***EX PARTE* REEXAMINATION COMMUNICATION TRANSMITTAL FORM**

REEXAMINATION CONTROL NO. 90/019,565 .

PATENT UNDER REEXAMINATION 10690336 .

The Third Party Requester (TPR) requested reexamination of claims 1-5 of U.S. Patent No. 10,690,336 (hereinafter the '336 patent) based upon the following proposed rejections:

Fig. 1 of the '336 Patent

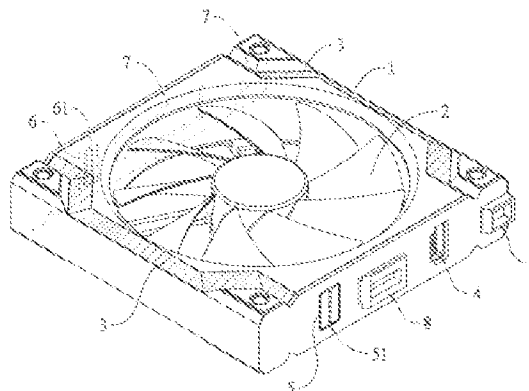
not further define the term “side”. There is no reference number in the drawings indicating what part(s) or region(s) of the body would fall within the scope of the term “side.” It is consistent with the patent disclosure to interpret the term “side” as referring either to lateral sides or to lateral areas or regions of the body, either with respect to a central line through the body or with respect to the central fan axis, because the position of the first and second connectors (5, 6) shown in Figs. 1-2 is consistent with such usage and because the disclosure does not include any more precise definition of the term “side.” Any of these interpretations would be consistent with dictionary definitions of the term “side,” which include “one of the lateral surfaces of an object, as opposed to the front, back, top, and bottom” (*Random House Kernerman Webster’s College Dictionary*, definition 3), “either of two lateral parts or areas of a thing” (*Id.*, definition 4), or “region, direction, or position with reference to a central line, space, or point” (*Id.*, definition 8). The interpretation of “side” according to either of the latter two definitions is also consistent with the language of the specification and claims describing the body as having a fan in center (*e.g.*, as the reference point from which the sides are defined), the first connector on one side, and the second connector on another side. Moreover, the examiner notes that claim 1 also uses the term “sides” in line 4 to refer to “at least two sides of the fan at the top of the body.” The term “side” appears here to refer generally to lateral areas or regions rather than to precise surfaces, which argues in favor of a broad construction of the term “side” when interpreting the language of the patent claims. Patent Owner’s argument that one of ordinary skill in the art “would have known that a fan body typically has four sides distinct from and adjacent to the top and the bottom” (Remarks, pg. 15; Declaration, ¶ 32) is not persuasive, because the scope of the invention is defined by the language of the claims, not by what is “typical” in the art. In this case, neither the claims nor the patent specification use the term “side” with such precision, as discussed above.

Patent Owner further argues that interpreting the term “side” to refer generally to a lateral area or region could render the claim indefinite depending on how the lateral areas or regions were divided. *See* Remarks, pg. 14-16; Declaration, ¶¶ 27-31. This argument appears to conflate breadth with indefiniteness. The examiner’s interpretation of the term “side” is broader than the interpretation put forth by Patent Owner. However, breadth is not the same as indefiniteness. *See* MPEP § 2173.04, citing *In re Miller*, 441 F.2d 689, 169 USPQ 597 (CCPA 1971); *In re Gardner*, 427 F.2d 786, 788, 166 USPQ 138, 140 (CCPA 1970). Patent Owner’s argument that a

broad reading of the term “side” would mean that the sides could be defined differently from what is recited in the claim is not persuasive because the invention is limited by the claim. In other words, the claim requires that the first connector is on “one side” and the second connector is on “another side,” which is sufficient to exclude the “nonsensical” hypothetical examples (to use Patent Owner’s term) put forth by Patent Owner in which both connectors are on the same side of the body or each connector is on both sides of the body (*see* Remarks, pg. 14-15).

Fig. 3 of the '336 Patent
(Annotated by Examiner)

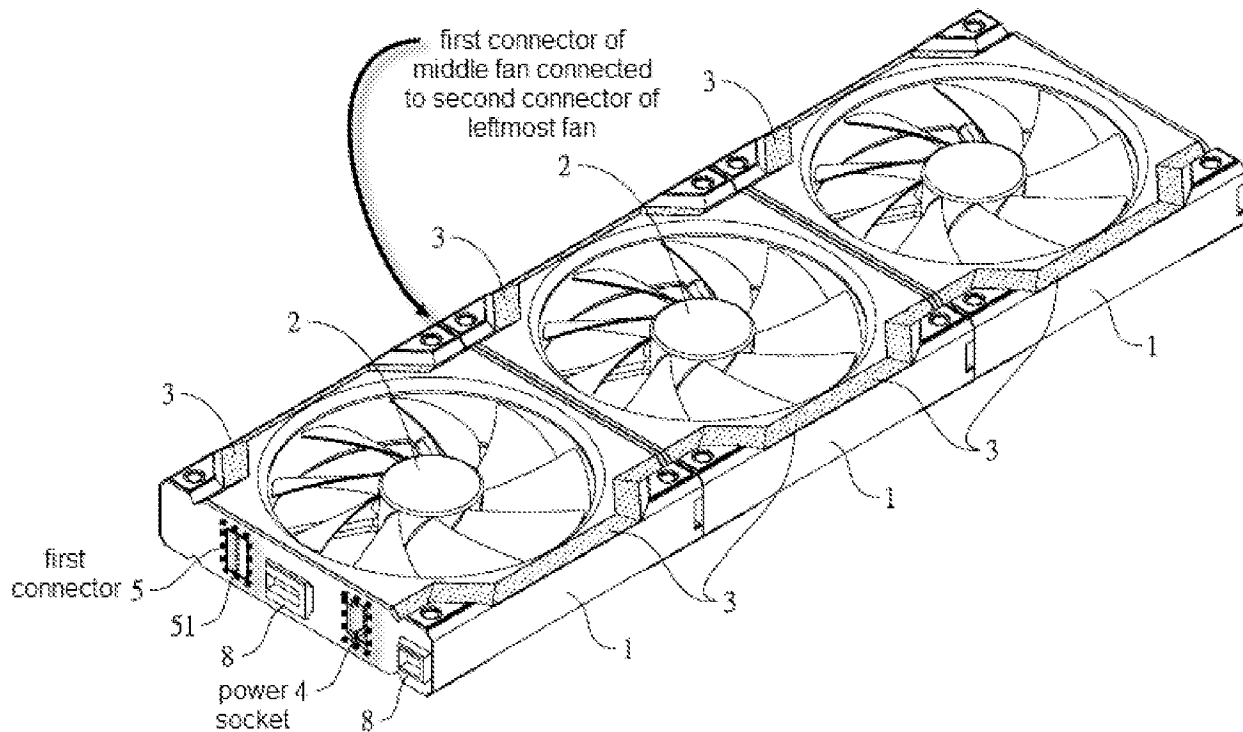
Fig. 3 of the ‘336 patent shows connected fans. Using Fig. 3 for reference, the first “when” clause is understood to refer, for example, to a fan configuration in which power is supplied to the power socket (4) of the positively claimed fan, corresponding to the configuration of the leftmost fan in Fig. 3. When power is supplied to the power socket (4) of the leftmost fan, then the fan and illumination area of that fan are respectively driven into rotation and illumination. The second “when” clause, by contrast, appears to refer to a different configuration in which, instead of supplying power to the power socket of the positively claimed fan, the first connector (5) of the positively claimed fan is instead connected to a second connector of another fan (and, presumably, a power socket of the “another fan” is supplied with power), corresponding to the configuration of the middle fan in Fig. 3. *See* annotated Fig. 3 below.

The claim description of two different conditional use scenarios appears to have led to some confusion reflected in Patent Owner's Remarks as to which connector of which fan is connected to which connector of which other fan. It is the examiner's position that Lai teaches an illumination fan having all of the structural features as claimed, and that the illumination fan of Lai is configured in such a way that the conditional functional limitations are satisfied when the power socket at the input of the illumination fan is supplied with power and when the input connectors of the illumination fan are connected to the output connectors of another illumination fan, as discussed in detail above.

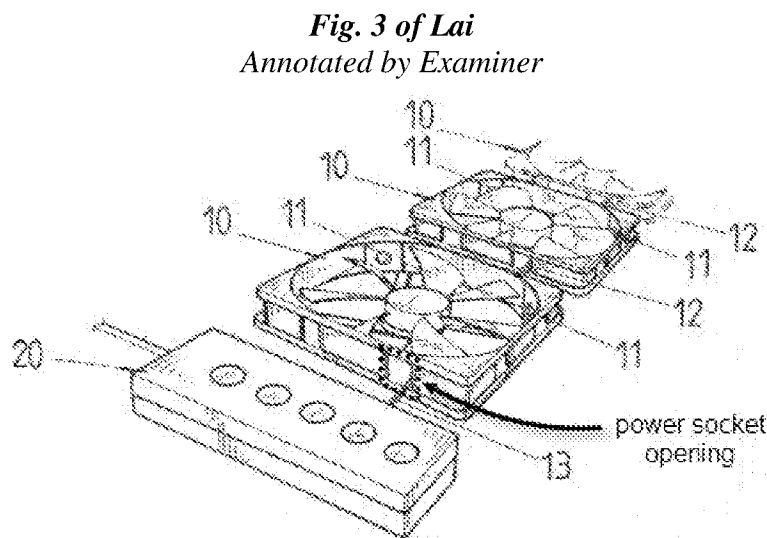
Although the schematic view of the fan shown in Fig. 2 of Lai illustrates the input (111) and the output connectors (112) on the same side of the fan body, the fan shown in Fig. 3 of Lai is understood to show the input and output connectors on opposite sides of the fan body, *e.g.*, for connection to a controller (20) on one side via a transmission line (13) and to another fan on another side via another transmission line (12), or for connection to one fan on one side via a

If there is any doubt regarding the examiner's interpretation of Lai as disclosing the power socket and the first connector being on one side of the body and the second connector being on another side of the body, then Fujitsu clearly discloses a fan (fan unit 10, Figs. 5-7) comprising: a body (fan unit 10) provided with a power socket (female power connector CNA and/or CNB, *see* ¶¶ 31 and 39) and a first connector (inter-fan connector CNC, ¶ 31) on one side of the body, and a second connector (inter-fan connector CND) on another side of the body. The power socket (CNA, CNB) is electrically connected with the first connector (CNC), the second connector (CND), a fan (11), and an illumination area (12; *see* Fig. 14). When the power socket (CNA, CNB) on the one side of the body is supplied with power, the fan (11) and the illumination area (12) of the body are respectively driven into rotation and illumination (*see* ¶¶ 27, 31, and 39-40). When the first connector (CNC) of the body is connected with the second connector (CND) of a body of another illumination fan, a fan (11) and an illumination area (12) of the body of the other illumination fan are respectively driven into rotation and illumination ("two adjacent fan units 10 among the plurality of fan units 10 are connected via inter-fan connectors CNC and CND that transmit the pulse signal from one end side to the other end side, and supplies power from one end side to the other end side," ¶ 31). Therefore, it would have been obvious to one of ordinary skill in the art to provide the body of Lai with a power socket and a first connector on one side of the body (*e.g.*, on the side adjacent to the controller, to which the transmission line 13 is attached in Fig. 3 of Lai) and a second connector on another side of the body (*e.g.*, on the side adjacent to the next fan in series, to which the transmission line 12 is

attached in Fig. 3 of Lai), as taught by Fujitsu, in order to facilitate a serial arrangement of fans (as shown in Fig. 3 of Lai and Figs. 5-6 of Fujitsu).

Regarding **claim 21**, Lai or the modified Lai teaches the claimed invention substantially as claimed, as set forth above for claim 1. Lai further teaches the power socket on one side of the illumination fan has an opening (*see* annotated Fig. 3 below) located on the one side of the illumination fan.
